ADDENDUM 2

PROJECT: Eugene School District 4J
Chinese Immersion Program Site & Building Renovation
at Kennedy Middle School (202014)
Eugene, Oregon

DATE: February 11, 2021

RE: Changes, Revisions, Clarifications and Additions

- 1 SERVE POWER TO EXISTING EXIT SIGNAGE FROM NEARBY RECEPTACLE CIRCUIT. USE SURFACE RACEWAY ROUTED VERTICALLY FROM SURFACE MOUNT RECEPTACLE TO CEILING AND HORIZONTAL FLUSH WITH CEILING TO LOCATION OF EXIT SIGNAGE. COORDINATE WITH ARCHITECT PRIOR TO ROUGH-IN.

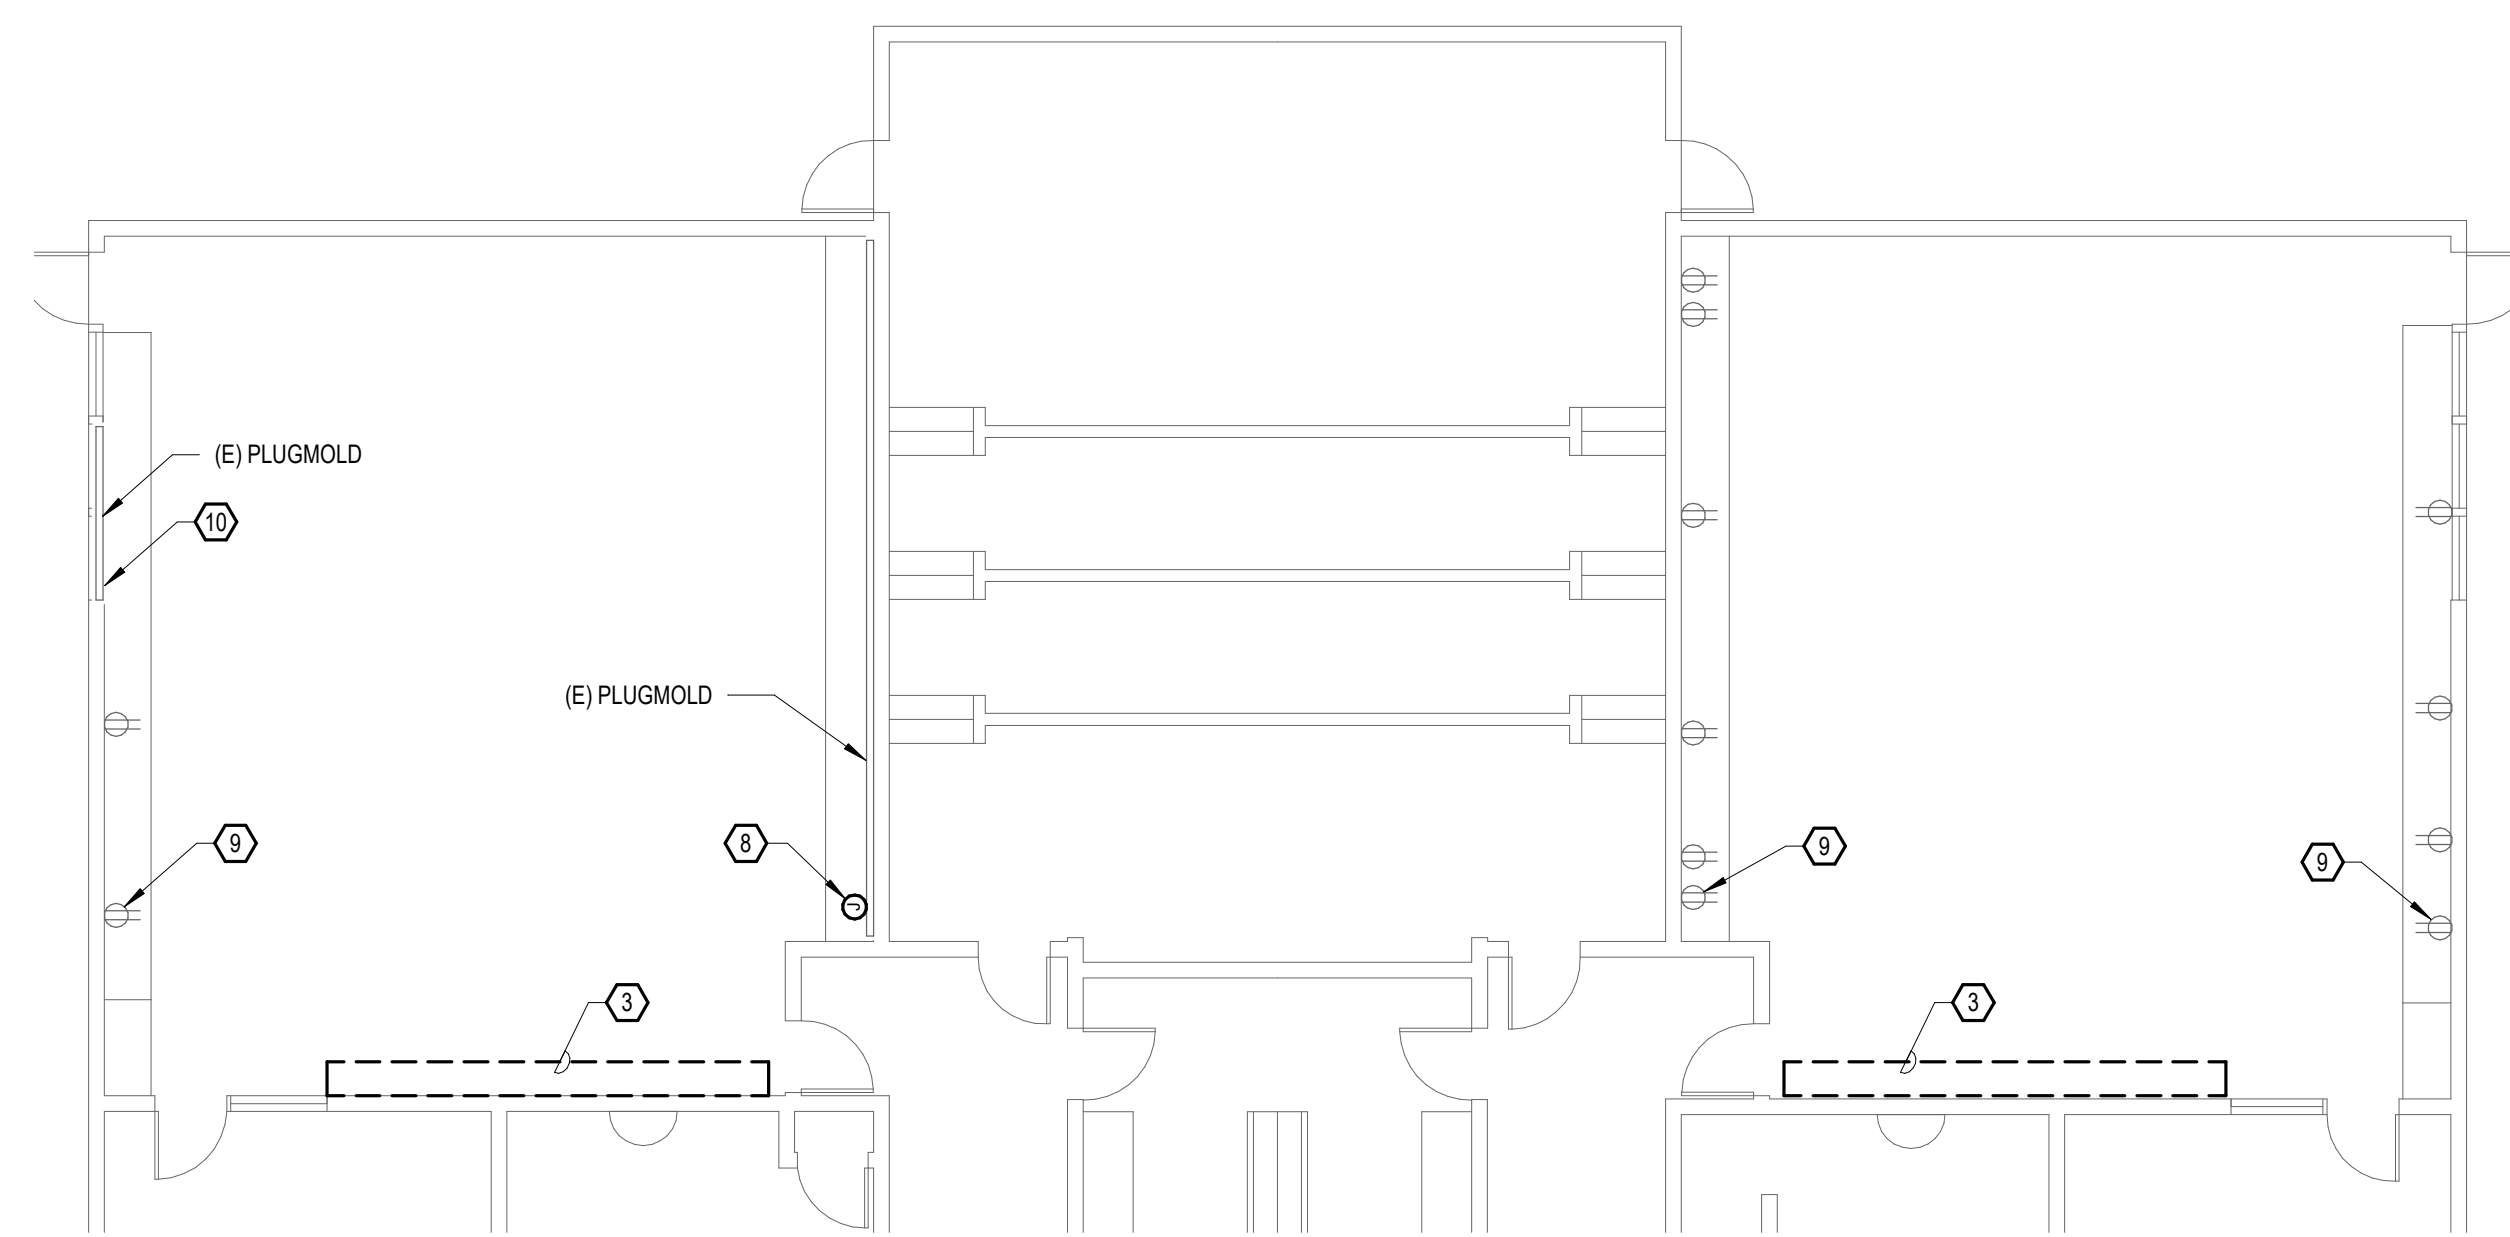
- Item 19: Reference Sheet A2.2 – BUILDING F FLOOR PLANS dated January 27, 2021, GENERAL NOTES; delete text for Items 3 and 6 and replace with the following:
- a. 3. PAINT INTERIOR WALLS OF ROOMS C-1, F-3, G-2, & G-4 IN THEIR ENTIRETY, COLOR TO MATCH EXISTING (WHITE), TYP
 - b. 6. NOT USED
- Item 20: Reference Sheet E101 – DEMOLITION PLANS dated January 27, 2021; Delete and replace with attached Sheet C101 – DEMOLITION PLANS with revisions dated February 10, 2021.
- Item 21: Reference Sheet E121 – POWER & SIGNAL PLANS dated January 27, 2021; Delete and replace with attached Sheet E121 – POWER & SIGNAL PLANS with revisions dated February 10, 2021.
